Our Case Number: ABP-314724-22

Re: Railway (Metrolink - Estuary to Charlemont via Dublin Airport) Order [2022]
Metrolink. Estuary through Swords, Dublin Airport, Ballymun, Glasnevin and City Centre to
Charlemont, Co. Dublin

Charlemont & Dartmouth Community Group MetroLink Submission

Dartmouth Road Submission

Figure 4: Railway Order Longitudinal Section (Dartmouth Road highlighted in red)

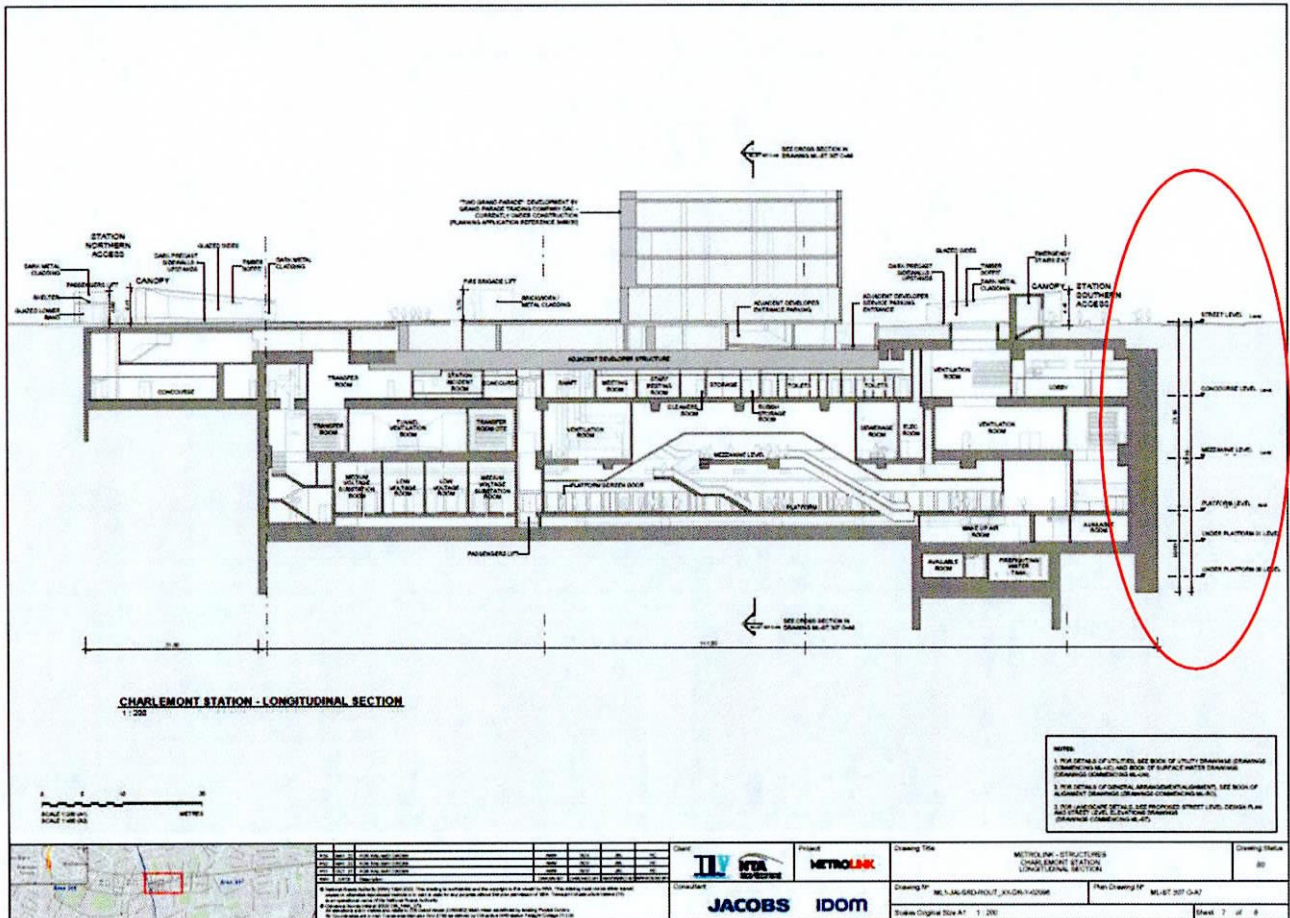
The longitudinal section is illustrated below. We contend that the submitted drawings are inadequate as they do not clearly illustrate the above ground elements. For example, the ground level drawing ML1-JAI-SRD-ROUT_XX-DR-Z-02090 illustrates the underground element of the station box extending up the southern carriageway of Dartmouth Road. Yet the longitudinal drawing no. ML1-JAI-SRD-ROUT_XX-DR-Y-02096 shows that the station box is on the northern side of the Dartmouth Road carriageway. This is wholly **misleading** and does not illustrate the proper relationship between Dartmouth Road and the station box. Furthermore, the Dartmouth Road houses are not illustrated on this section drawing.

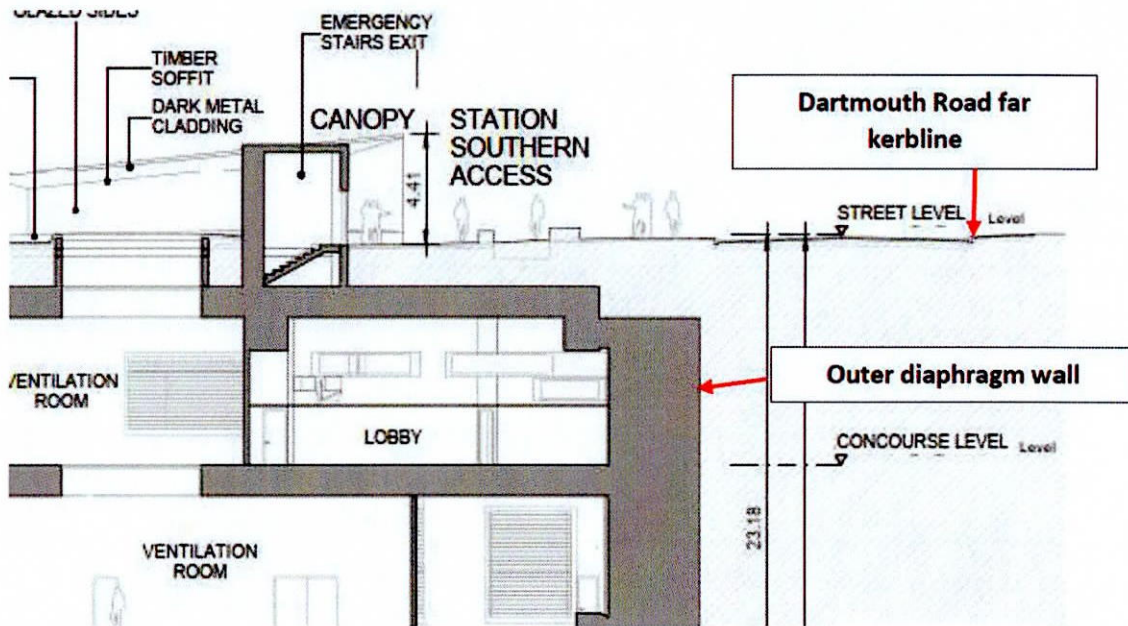
The alignment drawings do seem to indicate that the outer diaphragm wall boundary will extend under Dartmouth Road with the walling extending up to the far kerb line, as shown here in drawing ML1-JAI-ARD-ROUT_XX-DR-Y-03096:

Figure 5-10: Vertical Extent of Works at Dartmouth Road

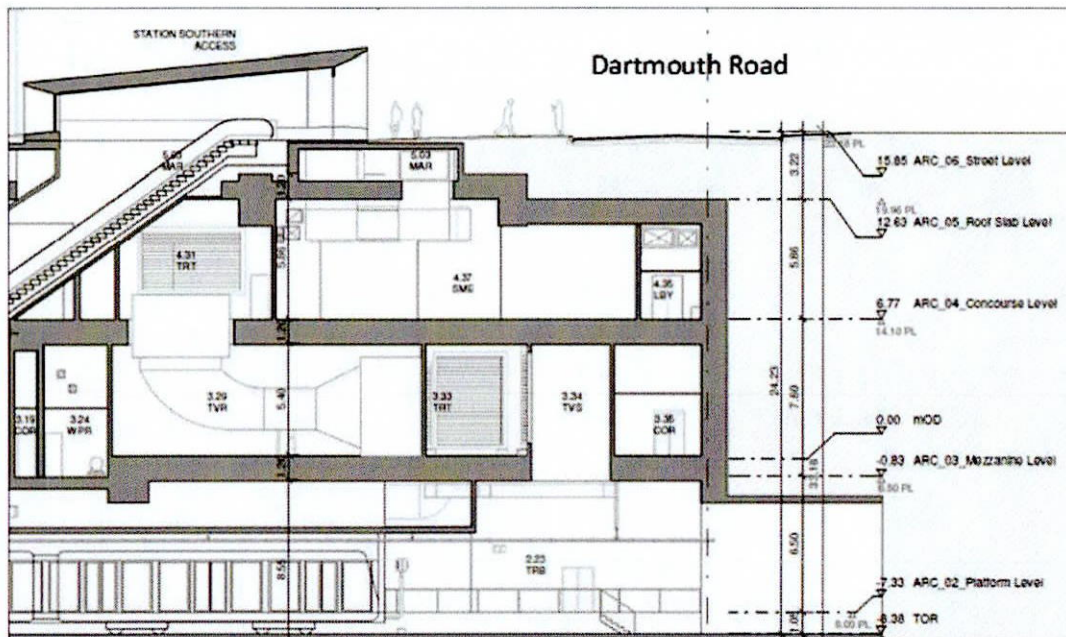
This drawing however is contradicted by figure 5.10 in EIAR Appendix A7.9, which clearly shows the D-walling near the far kerbline shown below:

Looking at the other drawings in the pack, it seems to be the case that Charlemont station box is by far the longest underground station box if the concourse extension is considered, or second longest (after O'Connell) if the extension is not considered.

Quite why the station needs to be this long is not clear to the IEE. While Appendix A7.9 Figure 3.2 does indicate that Charlemont will be as busy as Tara Street, hence the joint second busiest station on the network, the station box shown is far longer than that shown for Tara Street (shown as being only 105 metres in

Figure 15: Settlement Contours (Dartmouth Road highlighted with red oval)

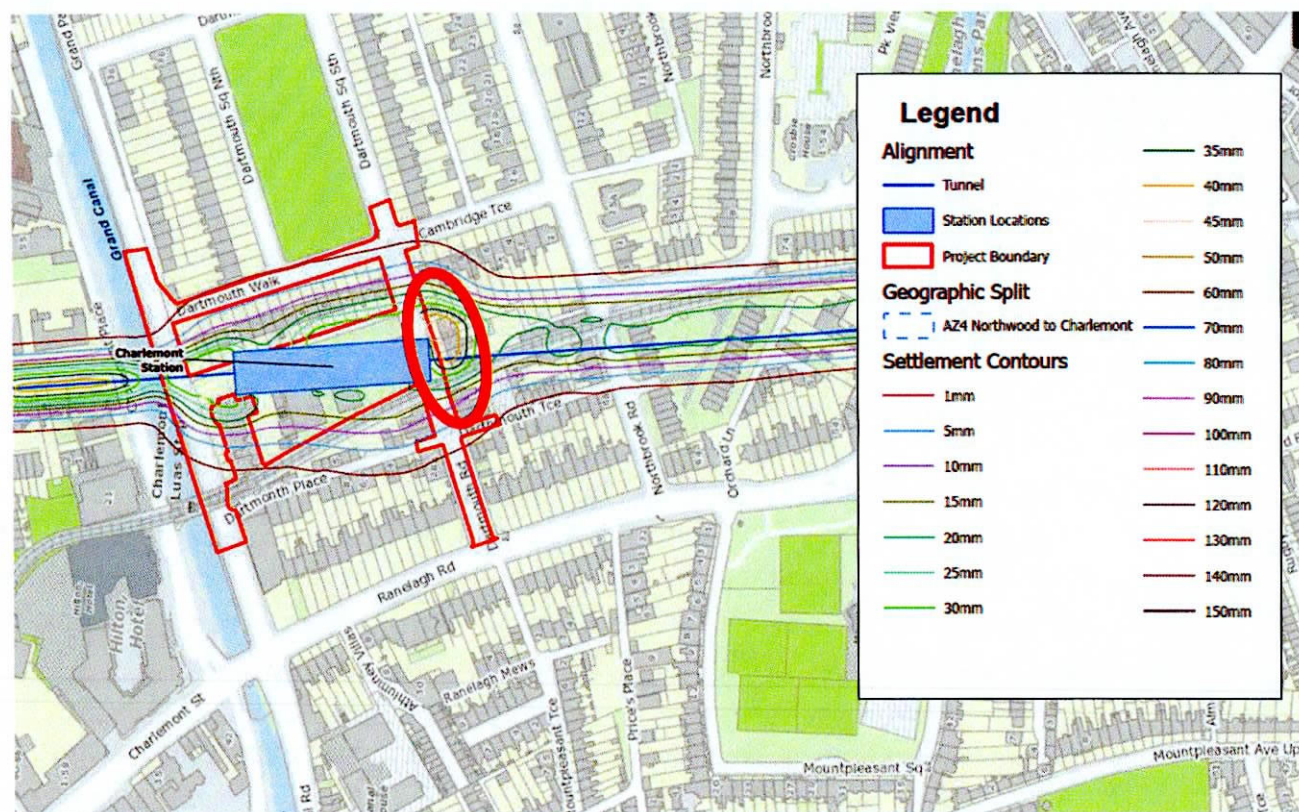
From a review of the EIAR and associated appendices, it is evident that a very limited assessment of settlement and subsidence has been carried out. It can be seen from the above diagram that the houses directly over the tunnels on Dartmouth Road fall within the 35mm to 45mm settlement zone. This is defined as "slight" risk category. We would query this classification as "slight". However, given that all bar one of the buildings covered by this submission are protected structures, they should be classed as damage category risk 3 (moderate). A phased system of assessment is proposed

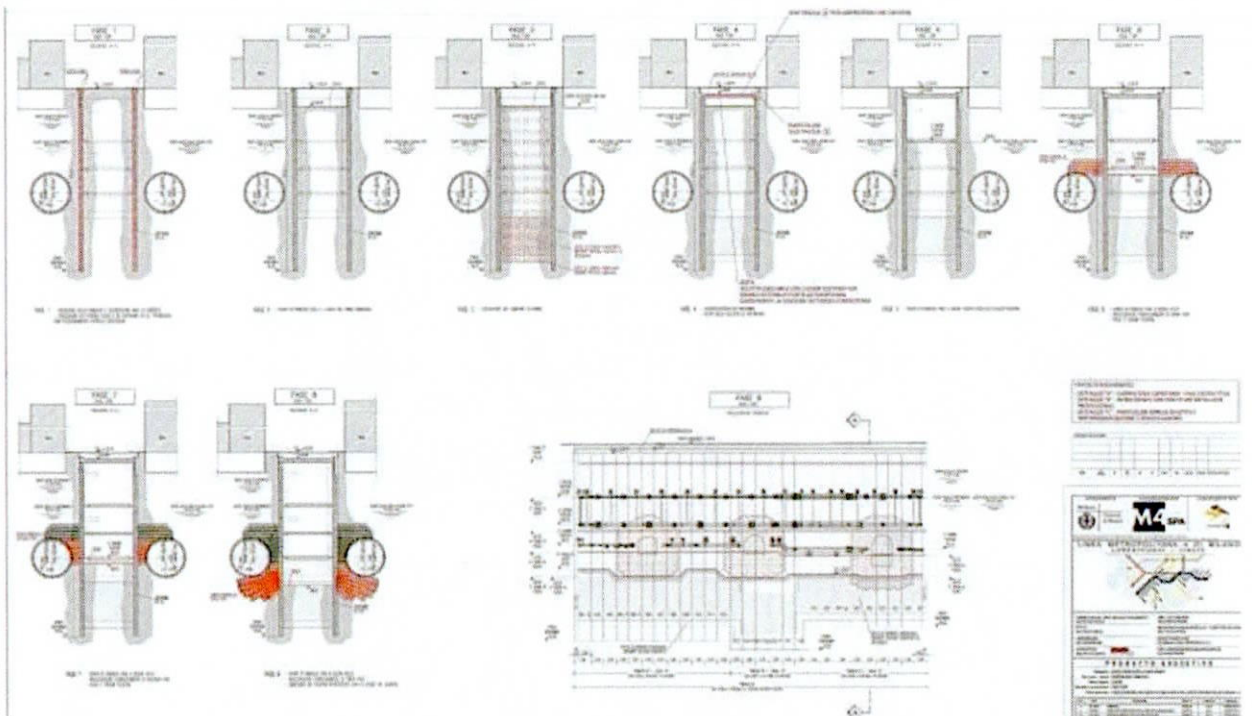
It is the view of the IEE, that even if it proves impossible or impracticable to move back the D-wall line from the far kerblines (see above) in any event there is no good engineering or planning reason to close Dartmouth Road for this extremely extended period. There are a number of alternative construction approaches, widely used, which would enable Dartmouth Road, which is quite narrow, to reopen after a matter of several weeks or a very few months two of which we outline below:

Likely to be used for the station construction in any event, the provision of the D-walling and top slab beneath Dartmouth Road would easily (and is commonly used for) allow the road surface to be re-instated. The actual length of this process will need to be discussed with the contractors but our proposal of several weeks to a very few months is very much possible, based on our international experience.

Figure 20: Ventilation and Exhaust System (outline in red)

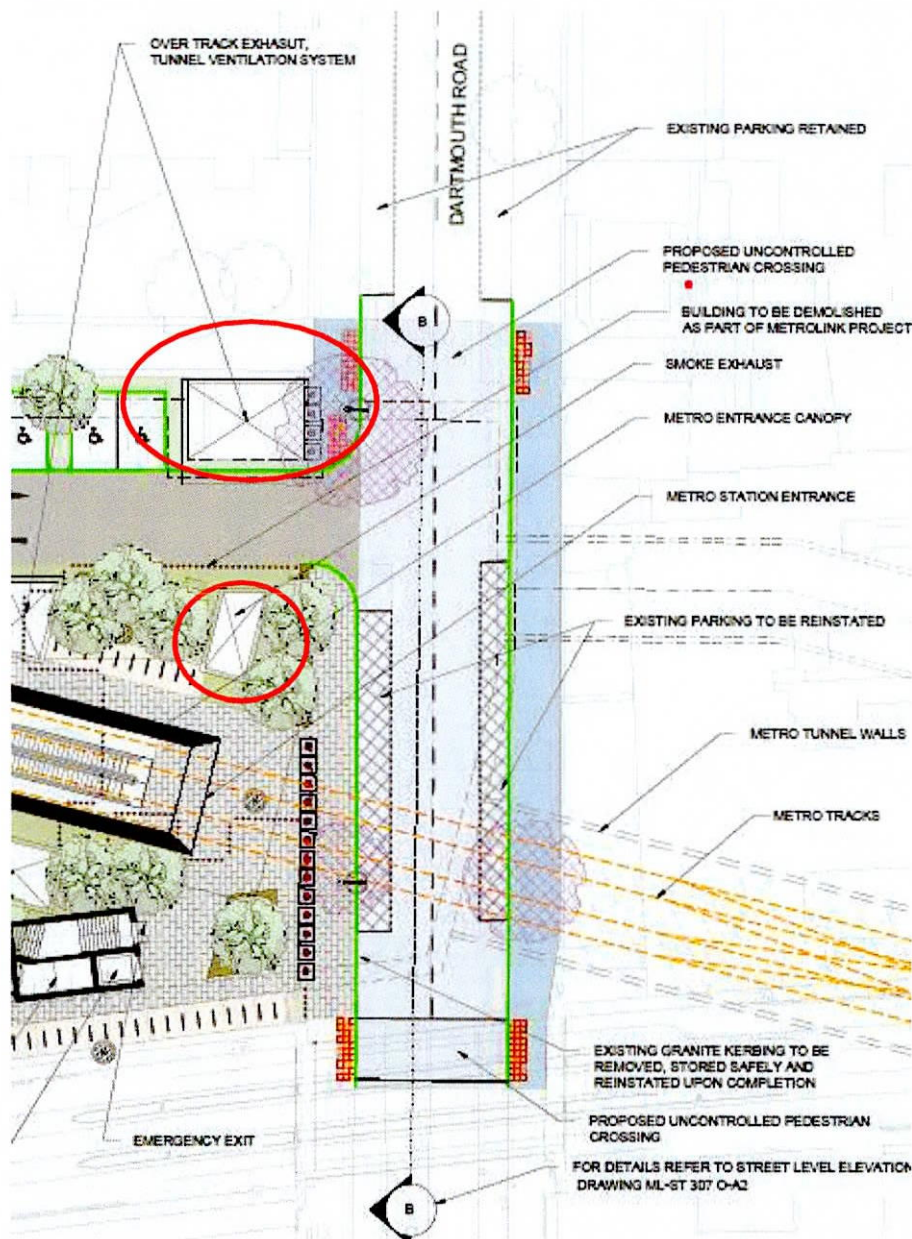
The proposed overtrack ventilation system and smoke exhaust gives rise to impacts that have not been properly assessed in terms of noise and air emissions. These systems are directly opposite nos. 34 and 35 Dartmouth Road and are highlighted in the extract from drawing no. ML1-JAI-SRD-ROUT_XX-DR-Z-02090.

We would emphasise here that specific noise levels from ventilation systems have not been assessed as part of this EIAR but rather would 'be calculated as part of the further design development.' **Effectively the impacts upon nos. 32 to 35 Dartmouth Road of the ventilation systems illustrated on the figure above have not been assessed.**

Figure 21: Surface and Traffic Layout

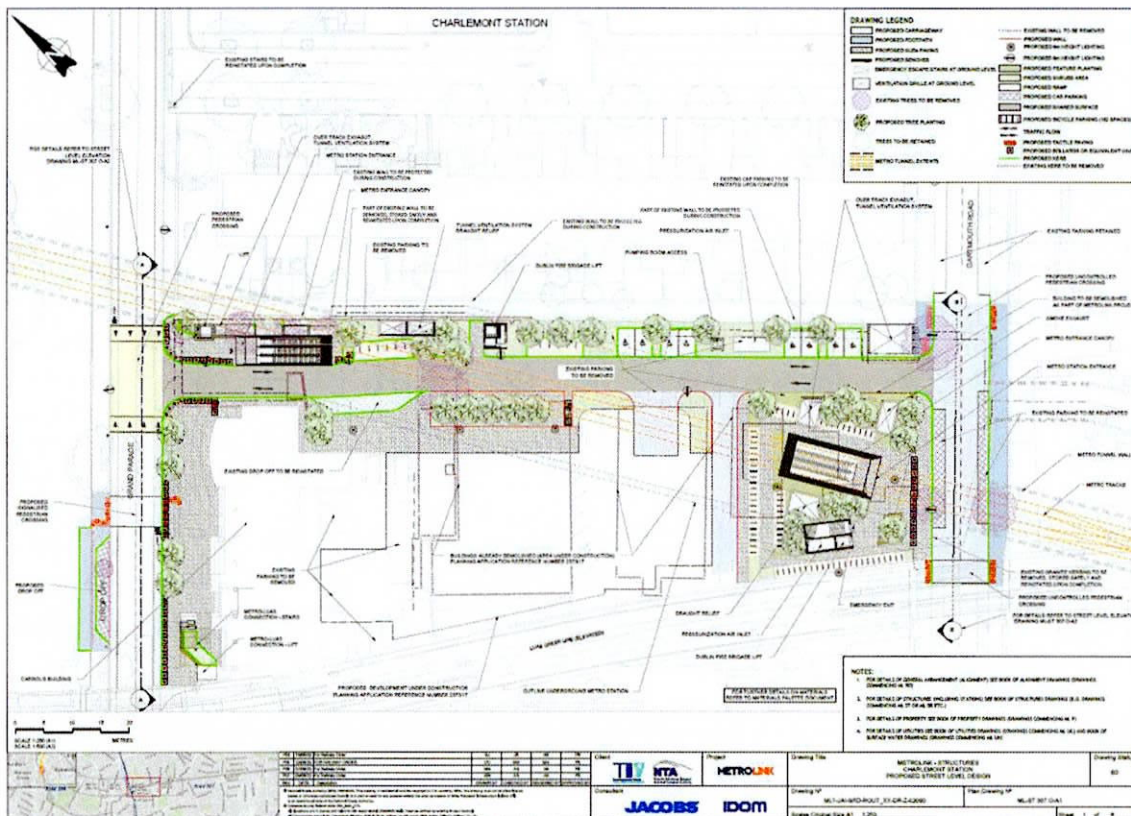
This is not however borne out by an examination of the submitted drawing no. ML1-JAI-SRD-ROUT_XX-DR-Z-02090.

Figure 21 below illustrates the operational road and street layout around the station. General drop-off and pick up this major interchange has been further considered in the associated general submission. The focus of this submission relates to Dartmouth Road. There is a major station entrance onto Dartmouth Road. It has no drop-off or pick facility and inevitably there will be a loss of parking for residents along this section of Dartmouth Road as the requirement for a drop-off and pick-up facility becomes evident. Given the very low level of integration with bus services in this suburban location, there will be a significant demand for such a drop-off

facility. No assessment has been undertaken of the demands, requirements and impacts of such a significant interchange element. This will result in a significant loss of amenity for local residents.

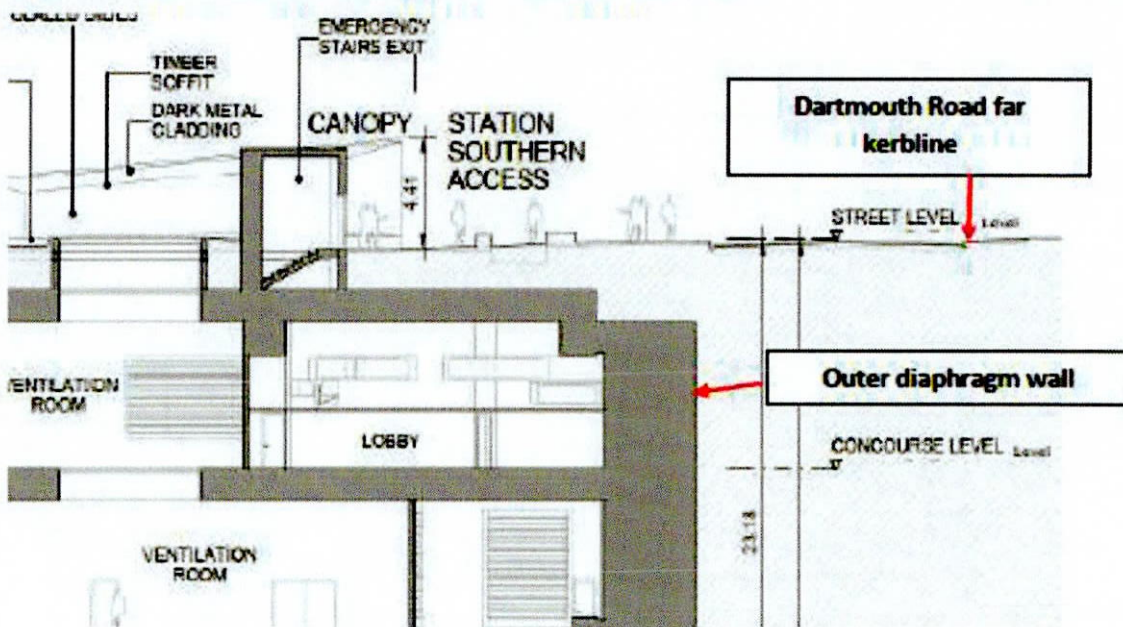
The alignment drawings do seem to indicate that the outer diaphragm wall boundary will extend under Dartmouth Road with the walling extending up to the far kerbline, as shown here in drawing ML1-JAI-ARD-ROUT_XX-DR-Y-03096:

Figure 5-10: Vertical Extent of Works at Dartmouth Road

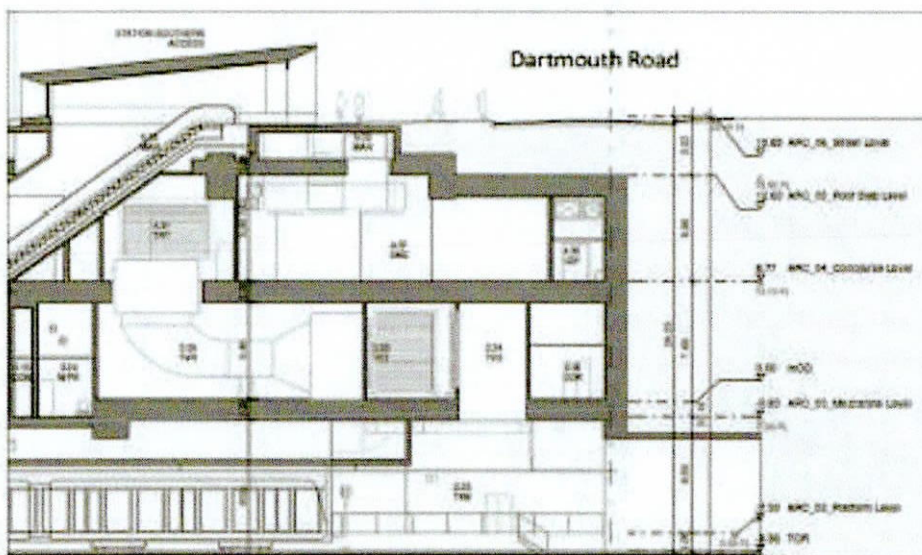
This drawing however is contradicted by figure 5.10 in EIAR Appendix A7.9, which clearly shows the D-walling near the far kerbline shown below:

Looking at the other drawings in the pack, it seems to be the case that Charlemont station box is by far the longest underground station box if the concourse extension is considered, or second longest (after O'Connell) if the extension is not considered.

Quite why the station needs to be this long is not clear to the IEE. While Appendix A7.9 Figure 3.2 does indicate that Charlemont will be as busy as Tara Street, hence the joint second busiest station on the network, the station box shown is far longer than that shown for Tara Street (shown as being only 105 metres in length). This is even more the case when considering that the trains themselves are planned to be of the order of 65 metres in length.

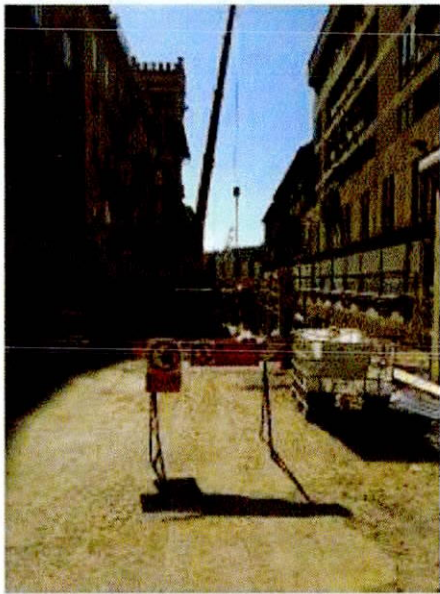
It is the view of the IEE, that even if it proves impossible or impracticable to move back the D-wall line from the far kerbline (see above) in any event there is no good engineering or planning reason to close Dartmouth Road for this extremely extended period. There are a number of alternative construction approaches, widely used, which would enable Dartmouth Road, which is quite narrow, to reopen after a matter of several weeks or a very few months two of which we outline below:

Likely to be used for the station construction in any event, the provision of the D-wall and top slab beneath Dartmouth Road would easily (and is commonly used for) allow the road surface to be re-instated. The actual length of this process will need to be discussed with the contractors but our proposal of several weeks to a very few months is very much possible, based on our international experience.
